**SUPPLEMENT TO PROJECT SPECIFIC PLAN  
SNAPSHOT MONITORING WELL SAMPLING AND  
SURFACE WATER AND SEDIMENT SAMPLING  
FINAL U.S. EPA AND OHIO EPA COMMENT  
RESOLUTION DECEMBER 1993**

FERNALD ENVIRONMENTAL MANAGEMENT PROJECT  
FERNALD, OHIO  
REMEDIAL INVESTIGATION AND FEASIBILITY STUDY

U.S. DEPARTMENT OF ENERGY  
FERNALD FIELD OFFICE

TYPE 1 WELL LOCATIONS  
FOR SNAPSHOT SAMPLING PLAN

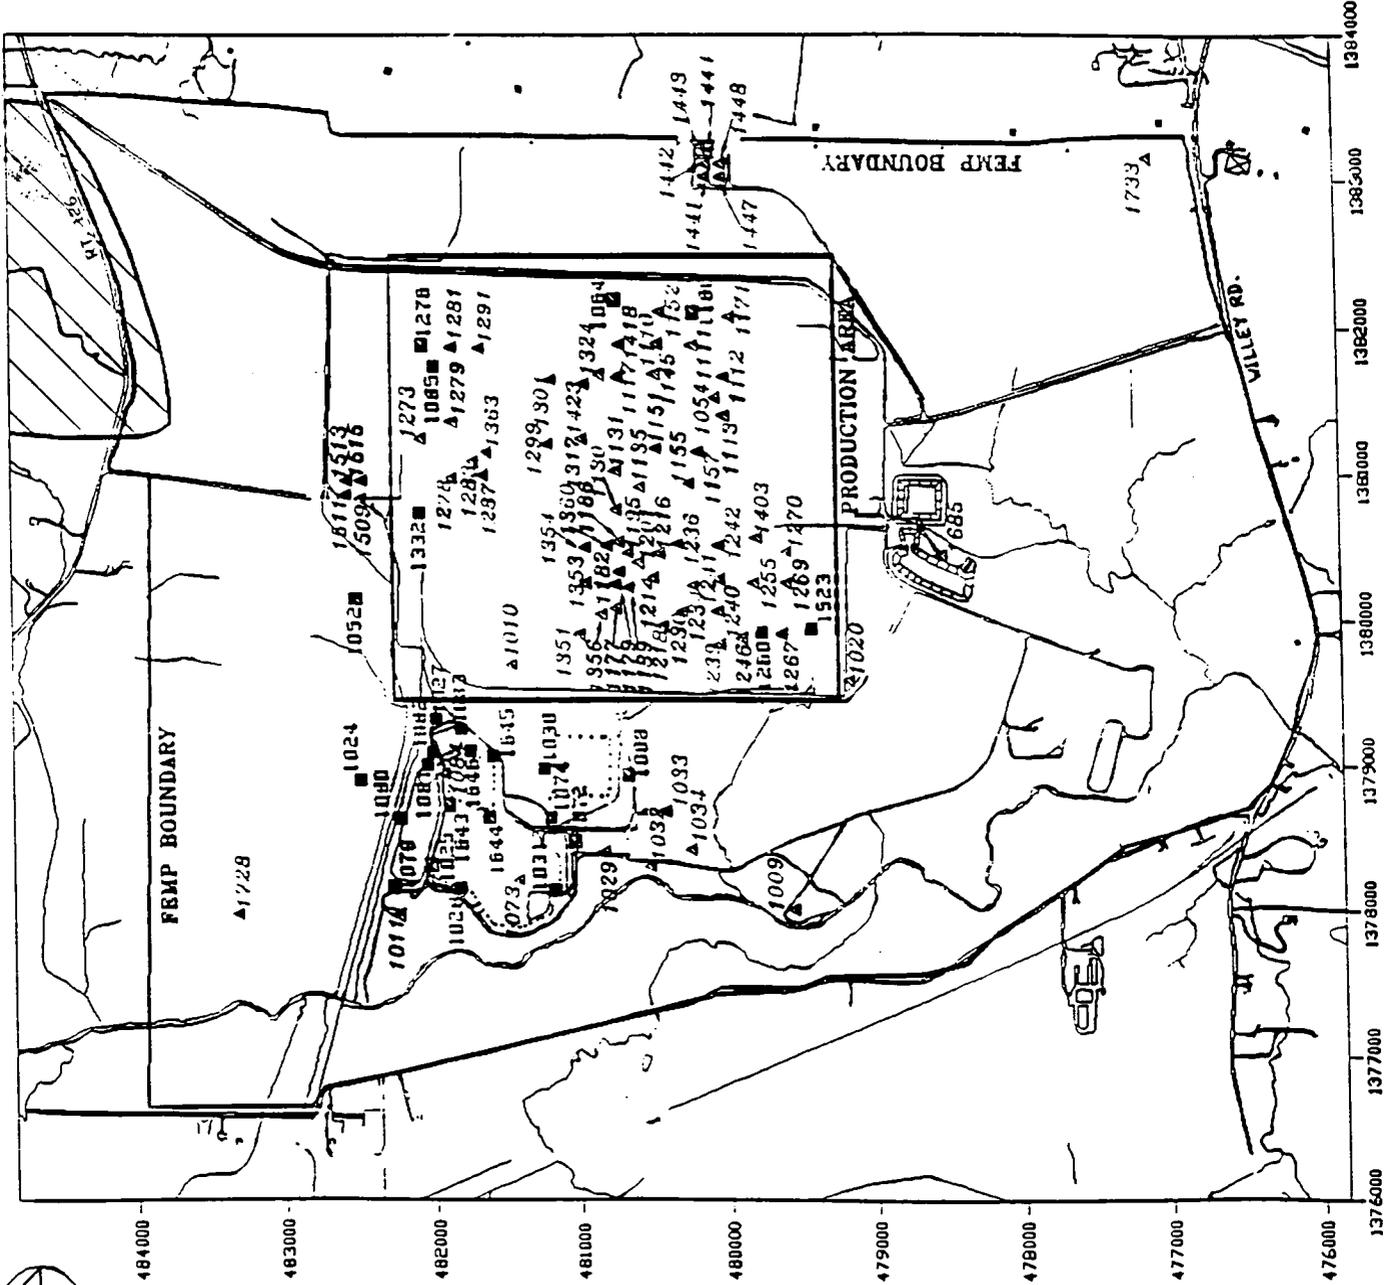
**Comment:** The text states that wells proposed for Snapshot sampling were selected to provide comprehensive coverage of the Site and surrounding areas. However, the text does not specifically state the criteria for well selection. The text should include a discussion of well selection criteria.

Comment: The work plan must include a figure(s)/plate detailing the locations of existing monitoring wells and highlighting those wells being incorporated into the Snapshot sampling. Without such a figure, it is difficult if not impossible, to evaluate DOE's selection of monitoring wells for inclusion. The necessity for such a map is further supported by the lack of text within the work plan describing the process of selection DOE used. A discussion of the selection process should be incorporated into the text.

Comment: These tables provide a list of existing wells to be sampled under the Work Plan Addendum. However, it is difficult to determine the adequacy of the wells chosen for snapshot sampling without a figure showing all the well locations and those sampled in the spring of 1993 and those proposed for the snapshot sampling. To allow U.S. EPA to better assess the adequacy of the wells chosen for sampling, a figure should be included showing all well locations and those proposed for snapshot sampling.

**Resolution:** The well selection was based on review of data from past groundwater sampling. The primary considerations were the importance of the well with respect to definition of the vertical and horizontal extent of contamination (i.e., the location of the well); and organic and radiological contaminant concentrations previously detected (with attention to comparison to health-based standards, such as MCLs). The major objectives were to define the horizontal and vertical limits of the contaminant plumes and to compare current conditions to past concentrations detected in the groundwater. Amendment USOC-1 presents revised Tables A-1, A-2, A-3 and A-4 which identify the monitoring wells sampled for Snapshot under all the sampling programs. Three maps depicting the locations of the Snapshot monitoring wells are included in this amendment.

Resolution: Amendment USOC-1 presents maps that indicate the locations of the wells. The well selection was based on review of data from past groundwater sampling. The primary considerations were the importance of the well with respect to the definition of the vertical and horizontal extent of contamination (i.e., the location of the well); and organic and radiological contaminant concentrations previously detected (with attention to comparison to health-based standards, such as MCLs). The major objectives were to define the horizontal and vertical limits of the contaminant plumes and to compare current conditions to past concentrations detected in the groundwater.

Action: Add figures to the PSP to show the locations of the wells identified in Appendix A of the PSP. Add a discussion of how the well locations were chosen.

Response: Maps that indicate the locations of the wells will be provided.

Action: Add maps to the PSP depicting wells to be sampled for the Snapshot program.
